# HISTORIC AND DESIGN REVIEW COMMISSION

December 01, 2021

**HDRC CASE NO:** 2021-589  
**ADDRESS:** 634 CEDAR ST  
**LEGAL DESCRIPTION:** NCB 2912 BLK 1 LOT S 10 FT OF 8 & N 40 FT OF 9  
**ZONING:** RM-4,H  
**CITY COUNCIL DIST.:** 1  
**DISTRICT:** King William Historic District  
**APPLICANT:** Kristin Hefty/Dado Group  
**OWNER:** Alex Garcia/GARCIA ALEJANDRO A  
**TYPE OF WORK:** Construction of a rear addition, site modifications  
**APPLICATION RECEIVED:** November 10, 2021  
**60-DAY REVIEW:** Not applicable due to City Council Emergency Orders  
**CASE MANAGER:** Stephanie Phillips

The applicant is requesting a Certificate of Appropriateness to construct a rear addition to the primary structure to measure approximately 530 square feet.

1 NEW SOUTH EXT. ELEVATION  
SCALE : 1/4" = 1'-0"

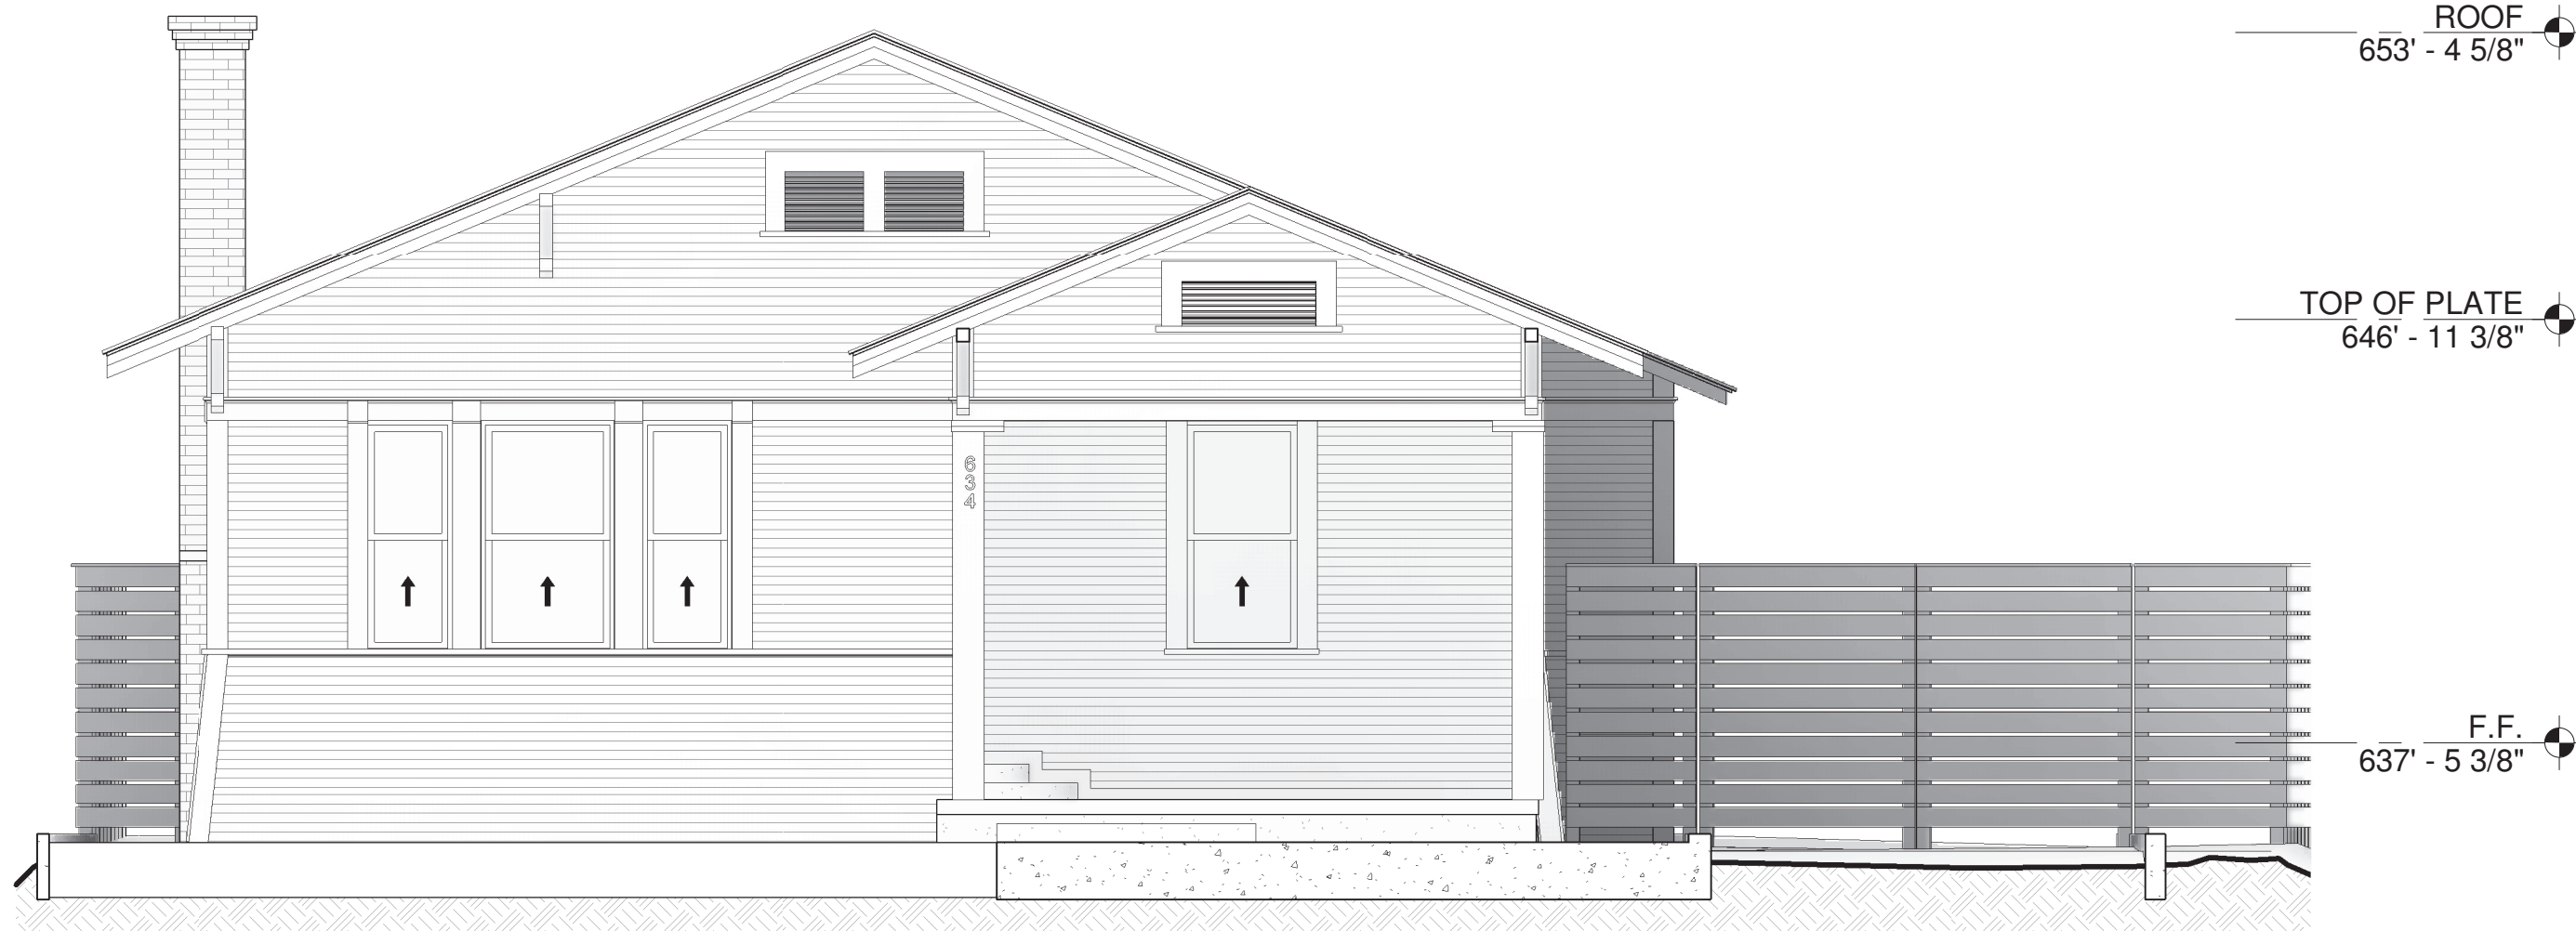
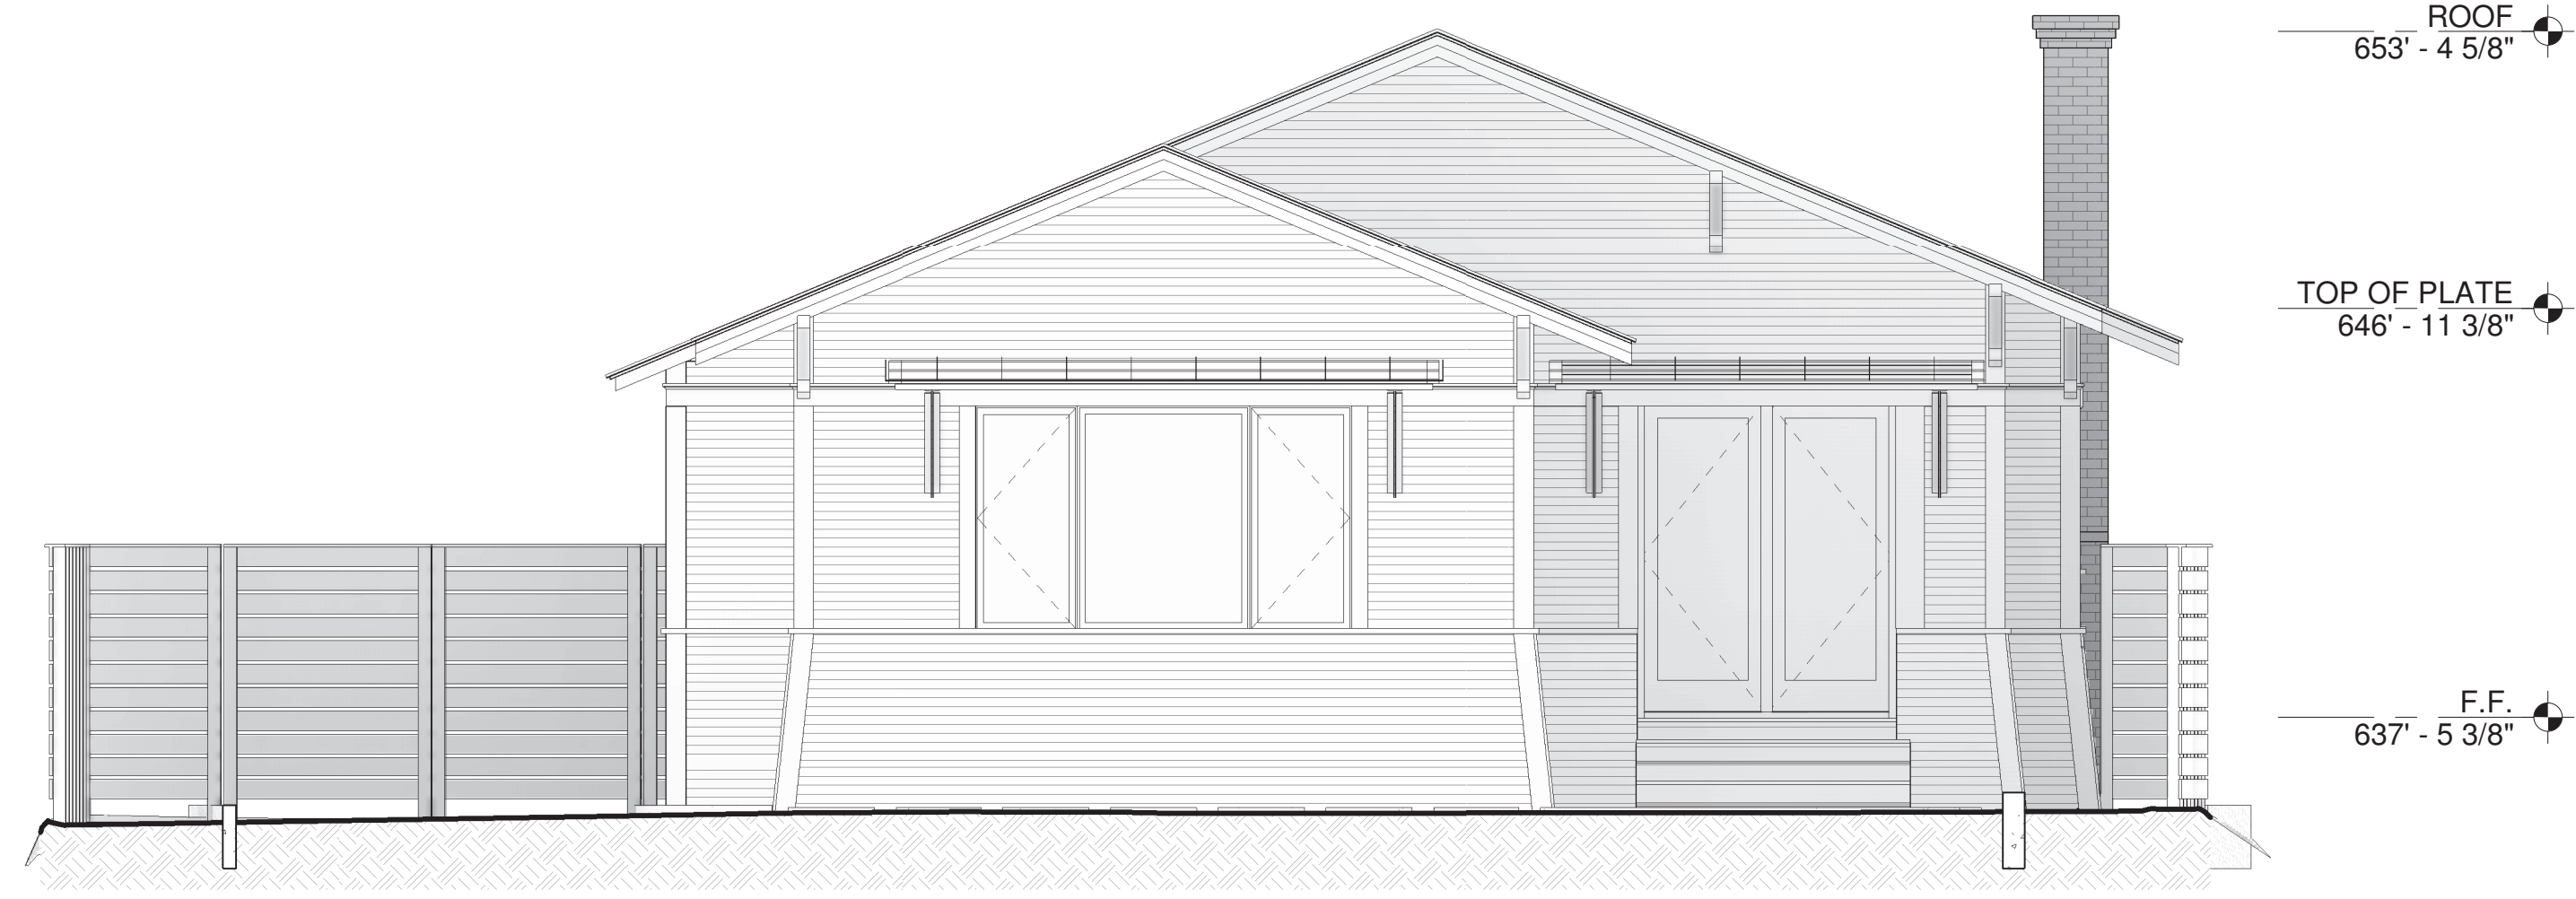
- e. FENESTRATION – According to the Historic Design Guidelines, openings in new construction and additions should use traditional dimensions and profiles found on the primary structure or within the historic district. Based on the submitted elevations, the applicant is requesting to use aluminum clad tri-panel casements and one small horizontal window. Staff finds that the existing wood windows that are in the location of the proposed

new addition should be reused in the addition in lieu of the proposed new windows. Updated elevations and a salvage and reuse plan are required.

- i. That the applicant repurposes the wood windows on the primary structure on the addition as noted in finding e. Updated elevation drawings and a salvage and reuse plan are required prior to the issuance of a Certificate of Appropriateness.
